# EASTERN CORRIDOR SEGMENTS II AND III (PID 86462) US 50 CORRIDOR FOCUS AREA ADVISORY COMMITTEE MEETING NOTES

## Meeting Dates

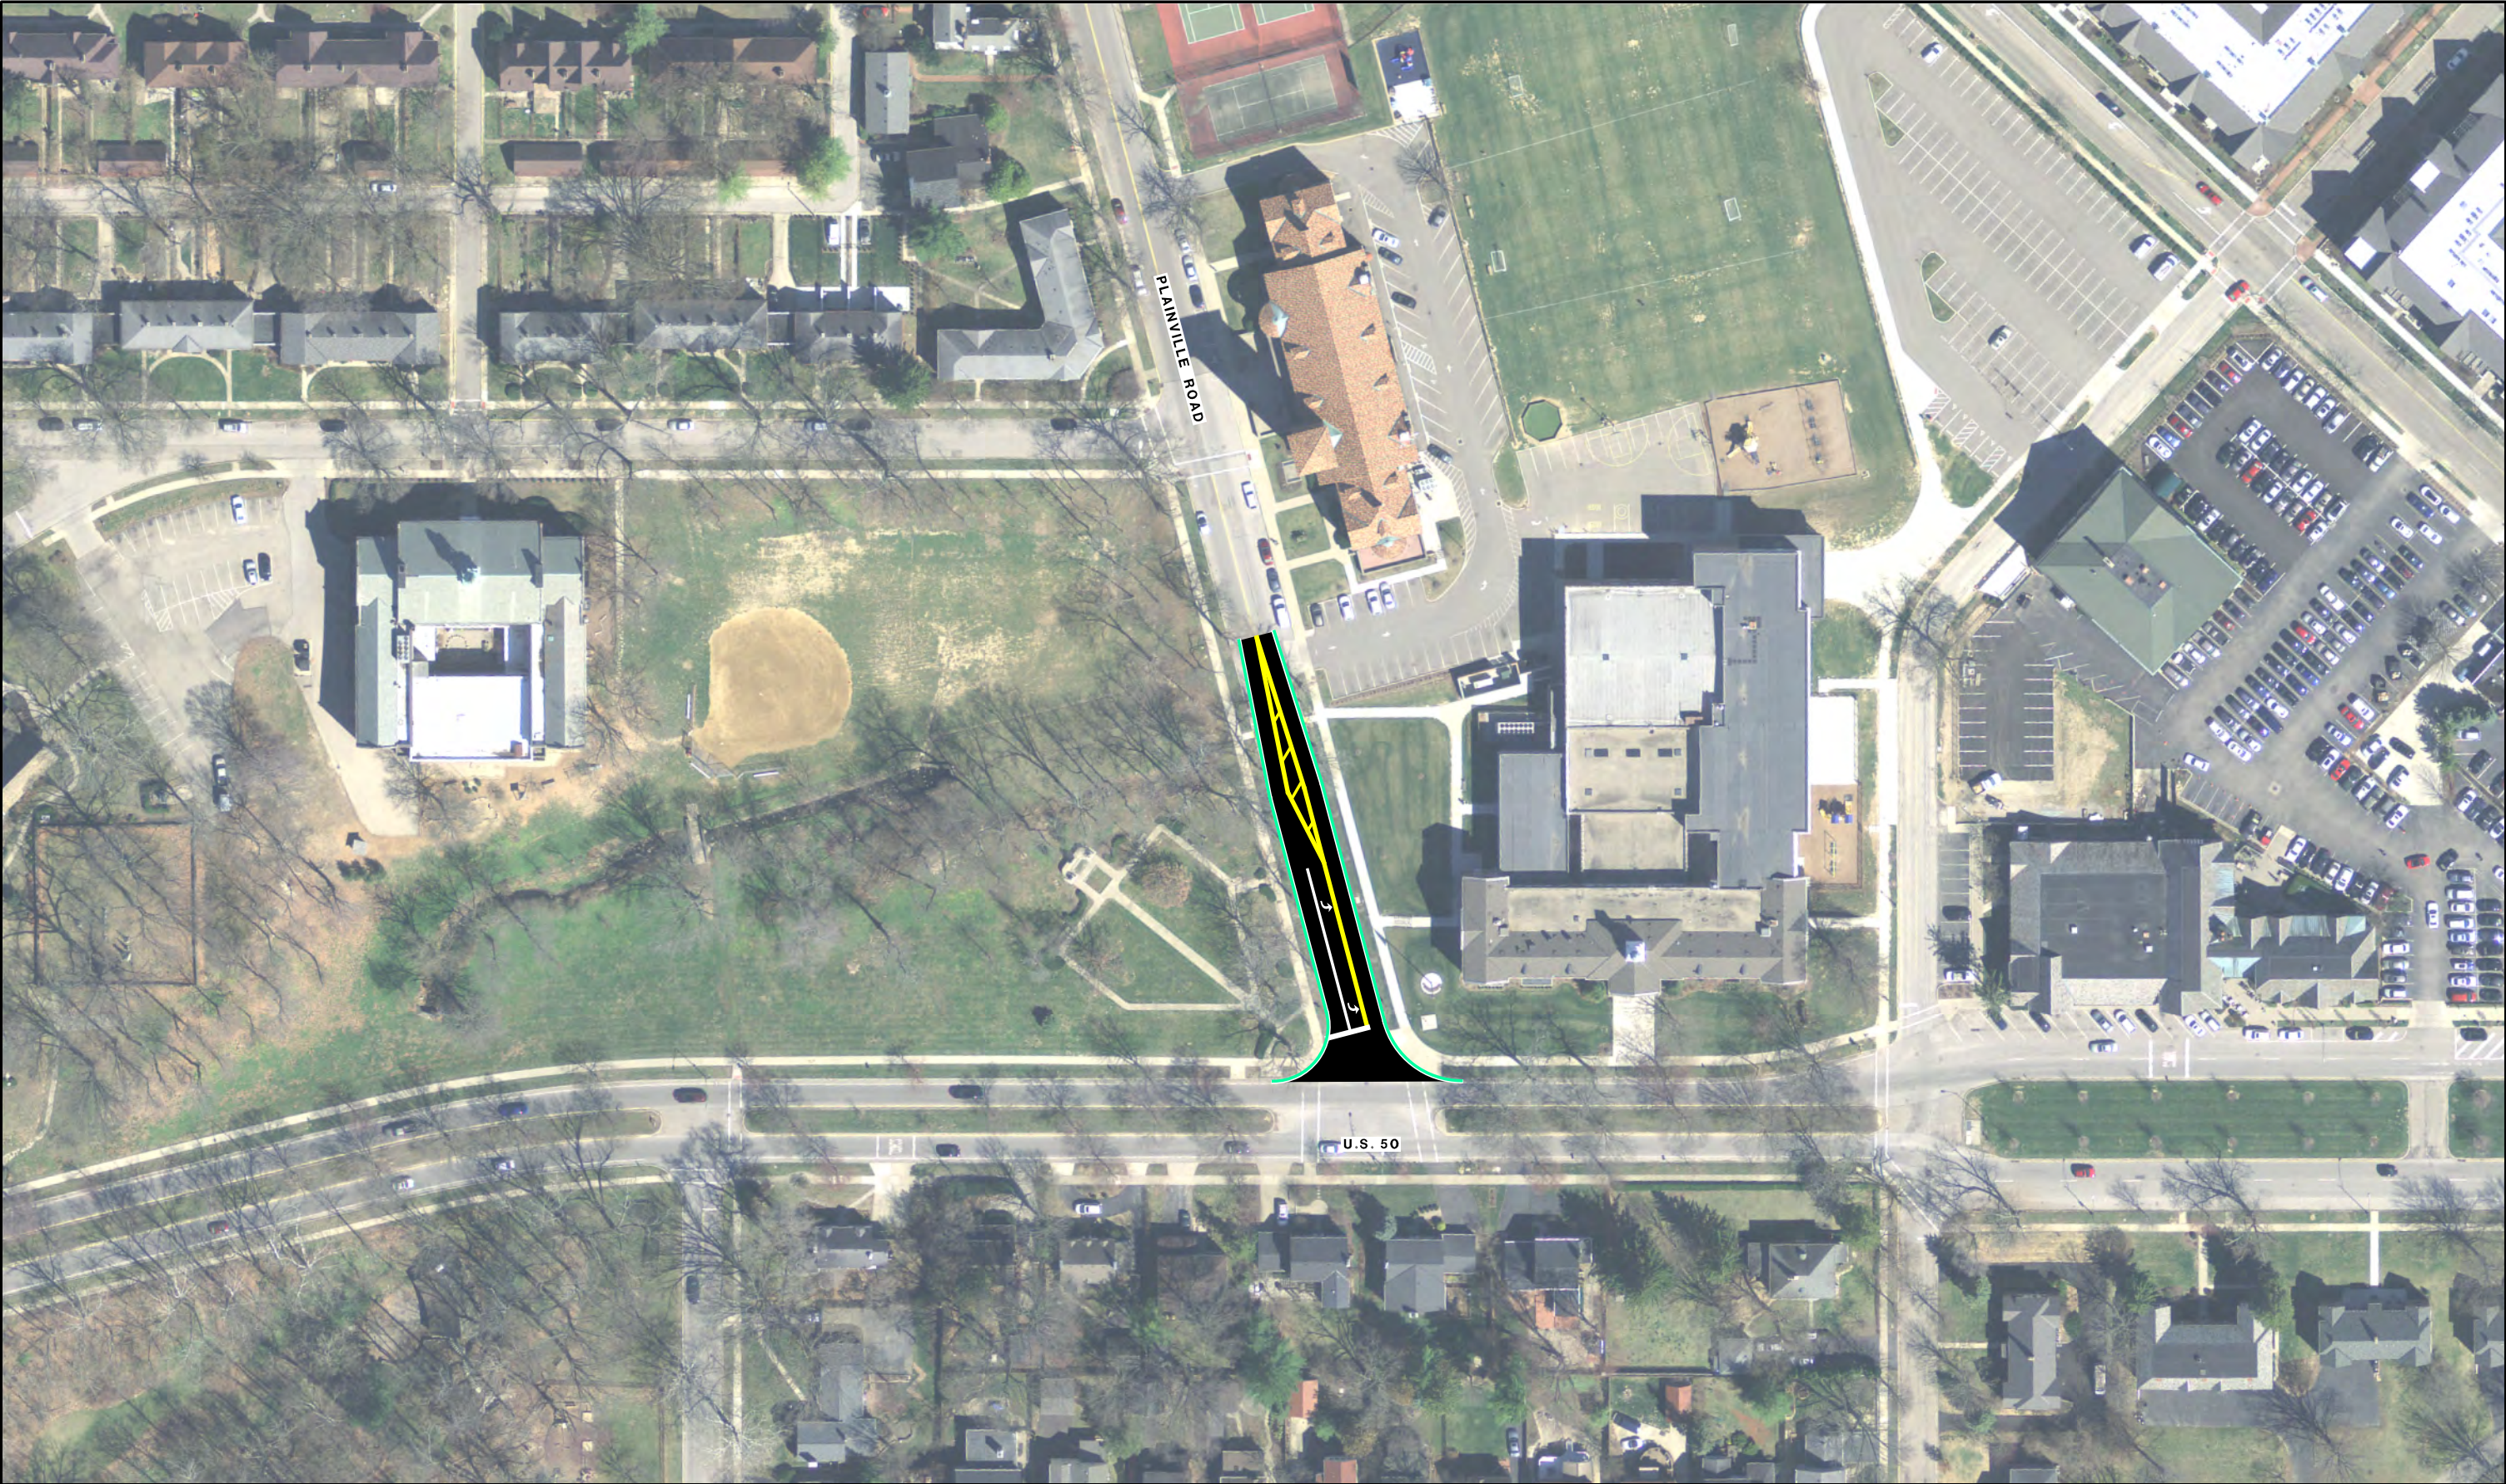
- The current width of lanes on Plainville Road would allow for adding a left turn lane by restriping the existing roadway.
- While this could alleviate the queues of drivers turning left from Plainville Road onto US 50 from blocking drivers turning right, initial analysis showed no traffic benefit of making this change. The southbound approach would still have a failing level of service at the intersection were this change to be implemented.

- Mariemont agrees to not further study changes at the intersection.

- Because this concept would not improve the intersection’s overall level of service, no further study is recommended.

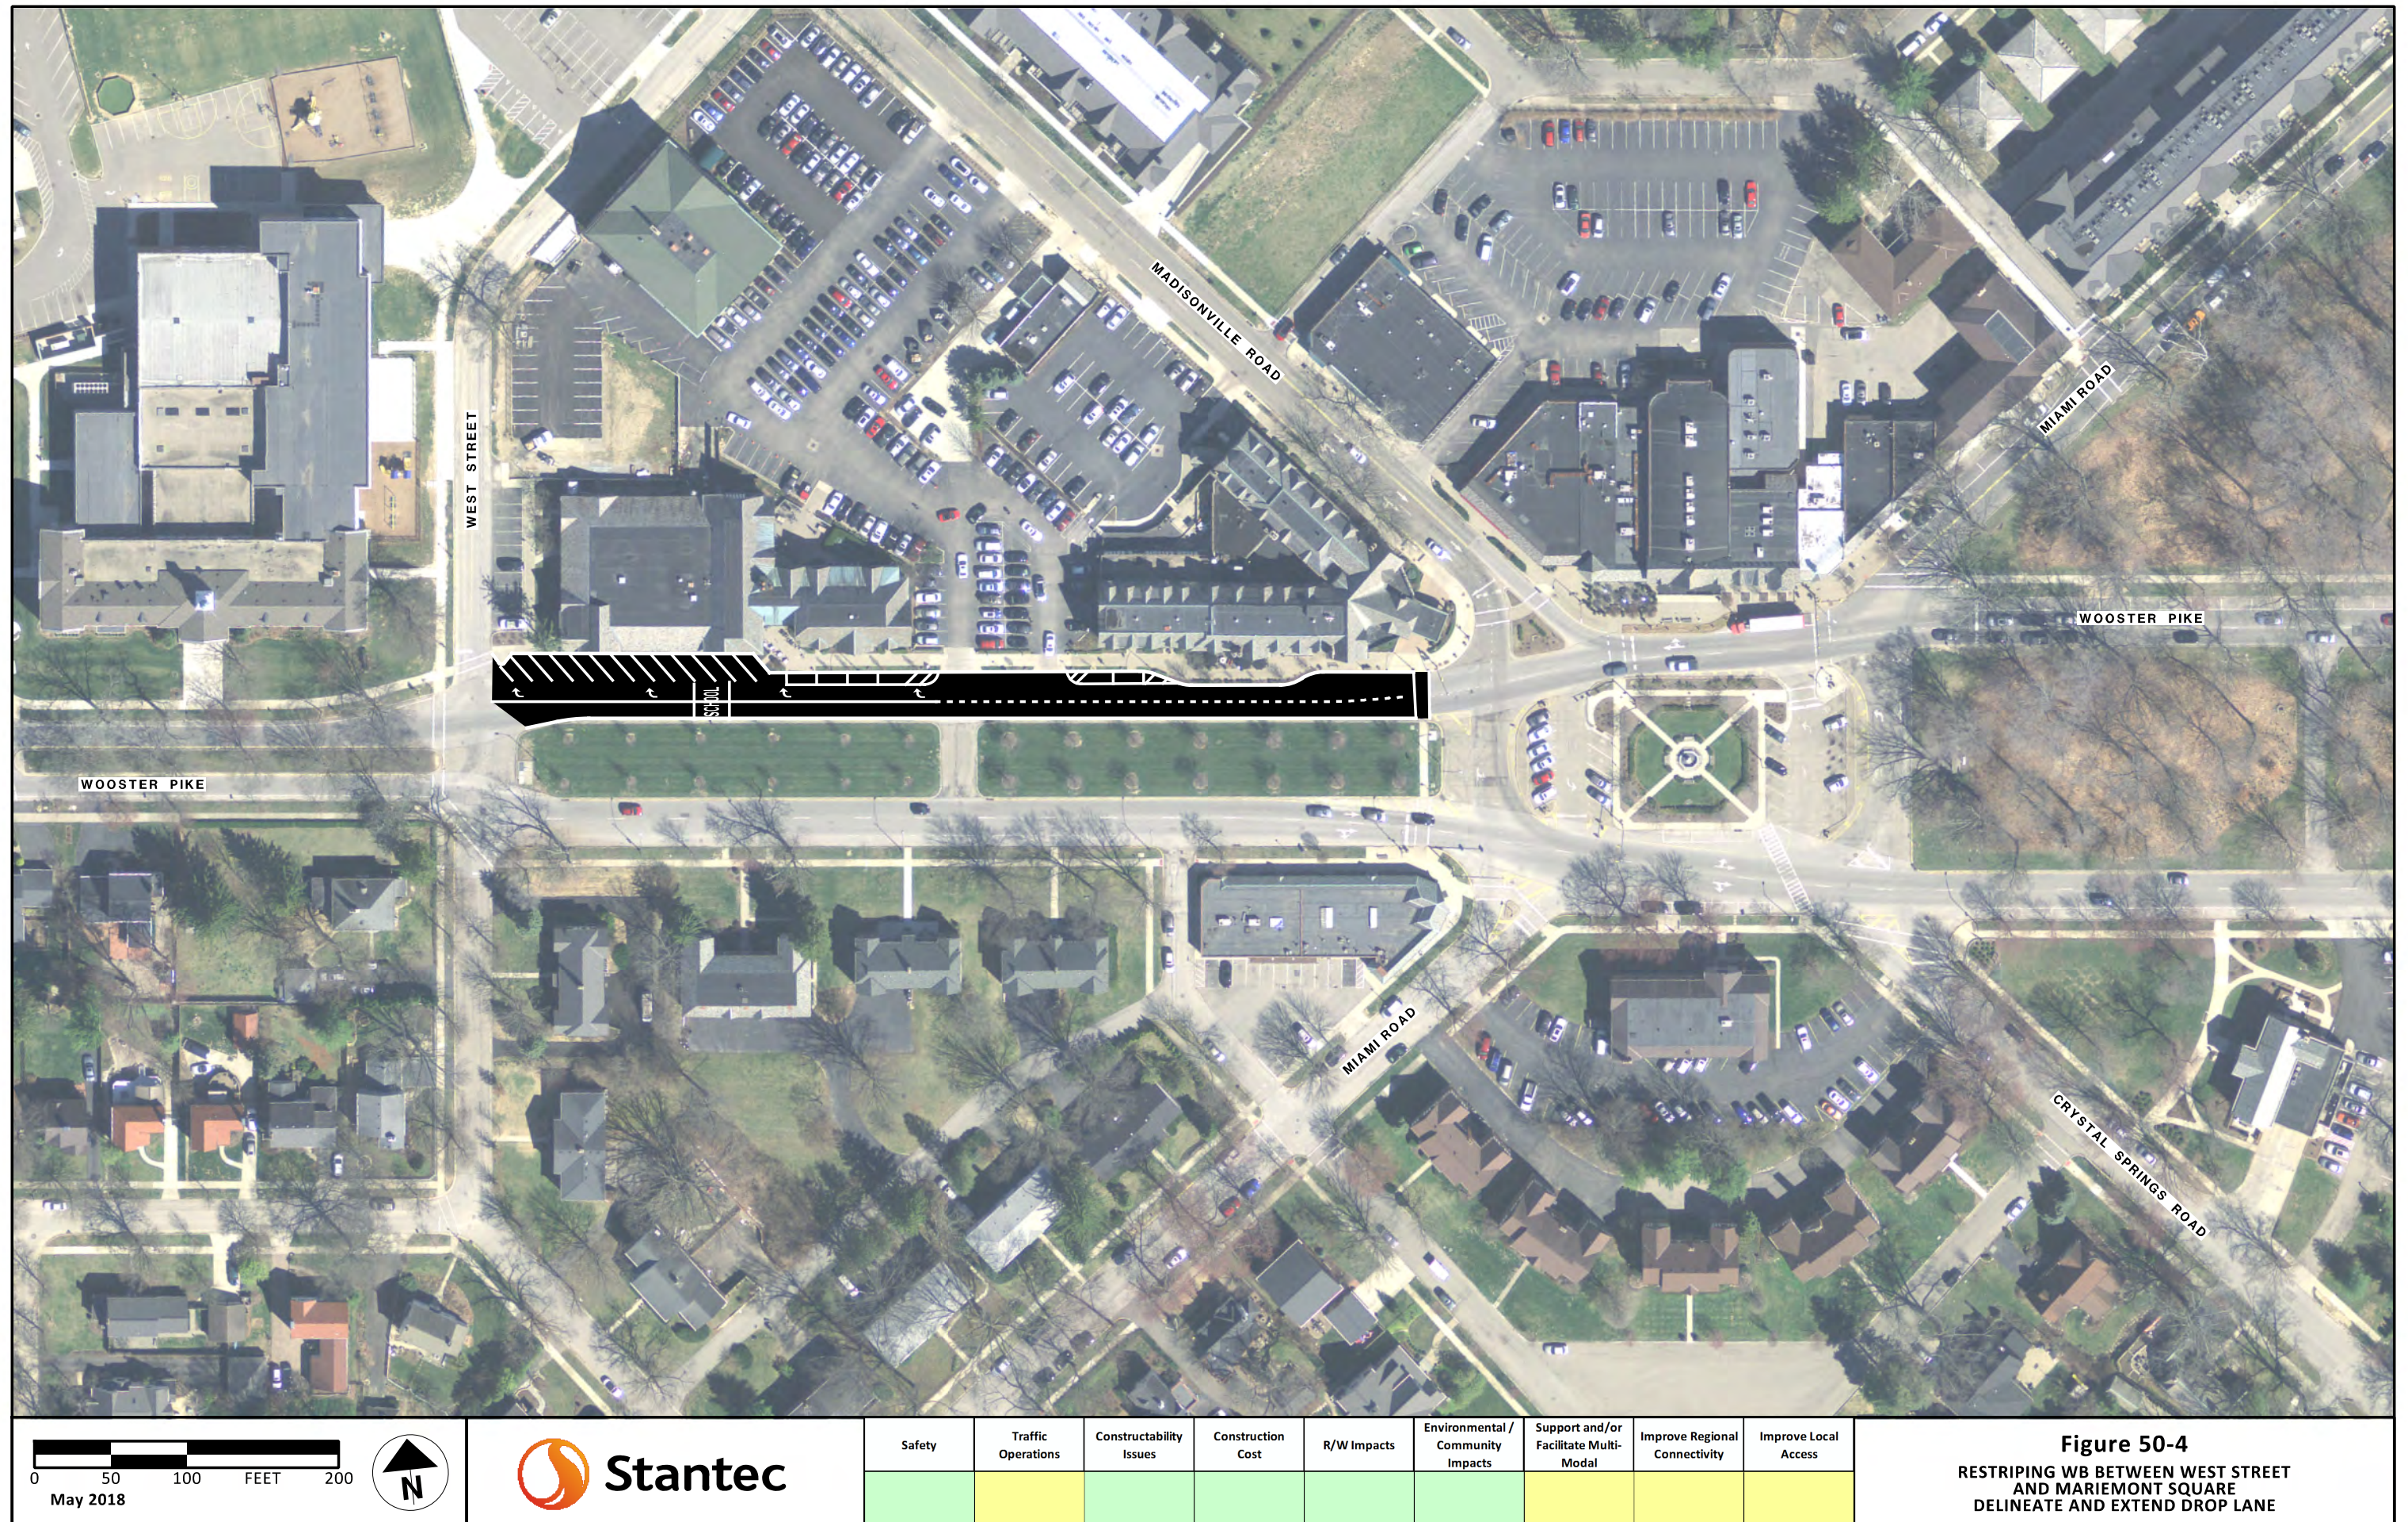
- Mariemont does not approve of extending the drop lane, and discussions with business owners in the area support this. The existing pavement with angled striping is frequently used for deliveries to the businesses, opening up valuable parking for customers within the parking lot.

- Due to a lack of support from Mariemont, this concept will not be advanced.

Alternate drawing for Concept I-13c, submitted by the Village of Mariemont. Drawing is meant to be a starting point for further discussions regarding improved safety at the square.

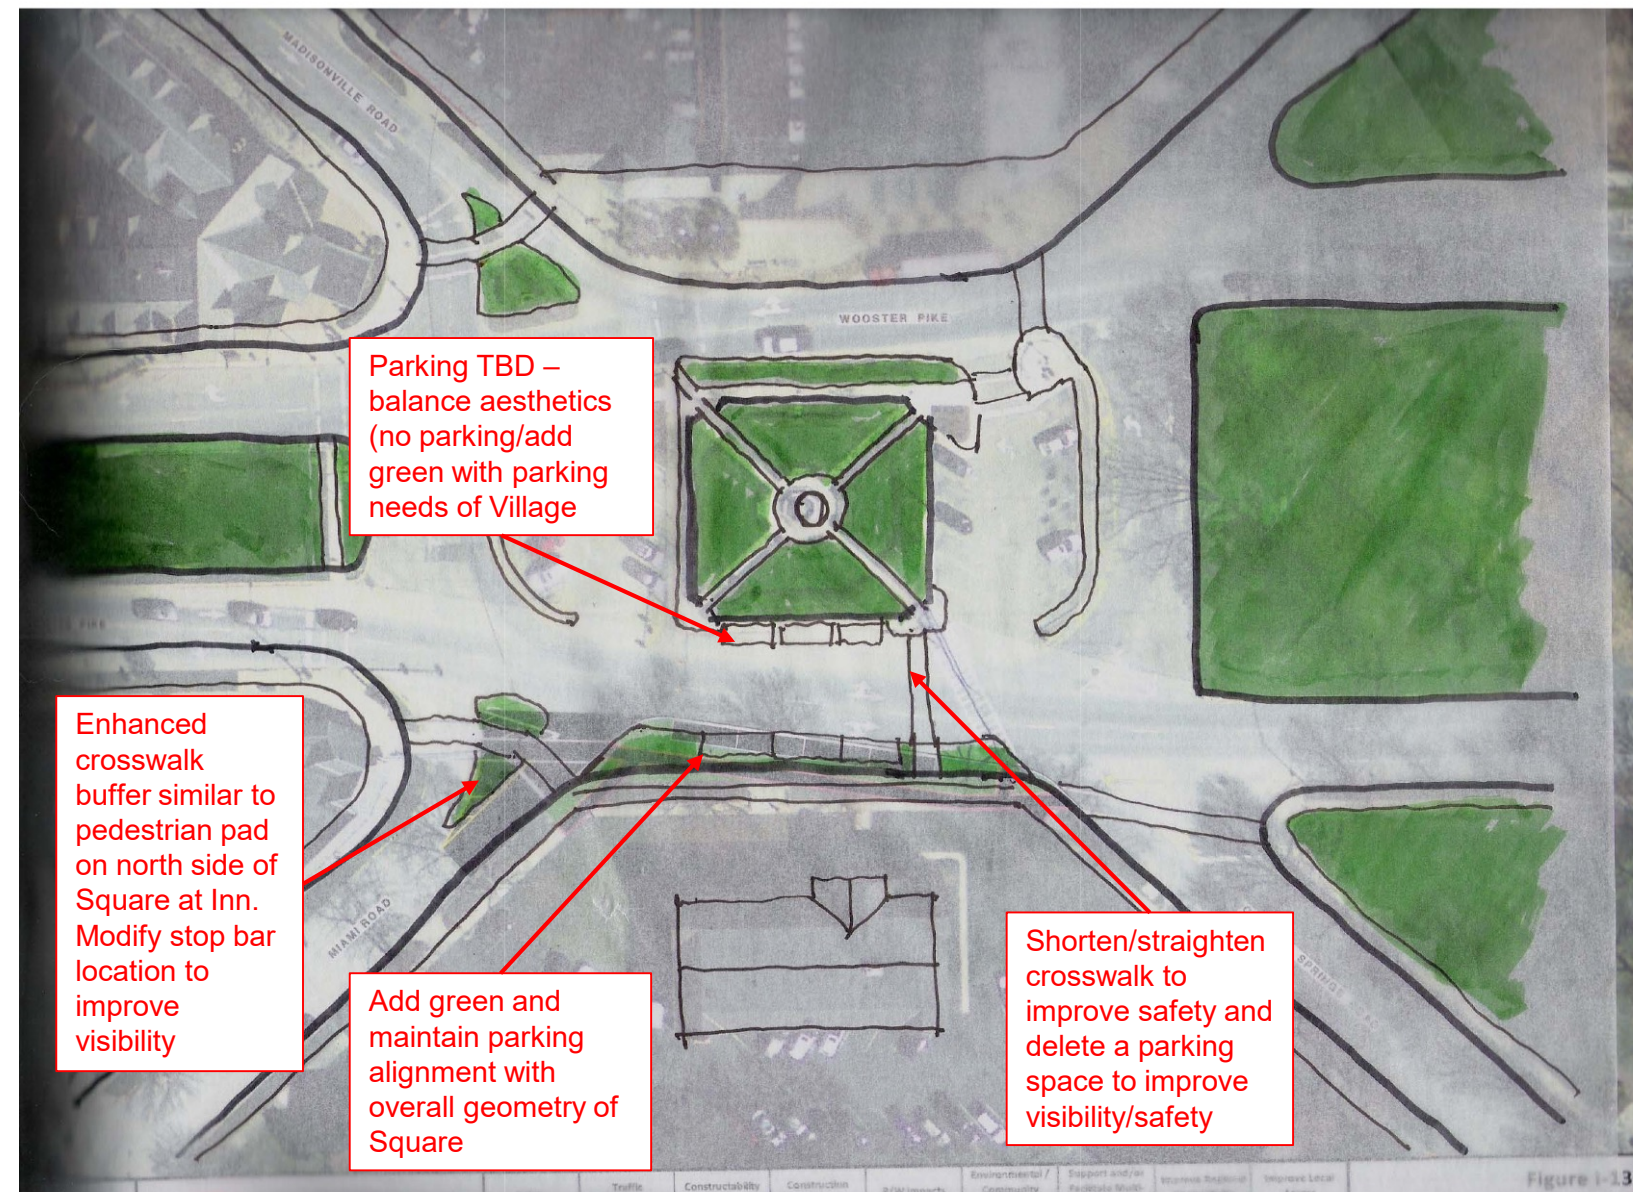
- Mariemont will provide sketch outlining design options. Limited time being allowed to submit comments did not allow Mariemont to submit sketch at this time. Continued dialogue is needed to address safety, parking and aesthetics.

RECOMMENDATION: NO FURTHER STUDY
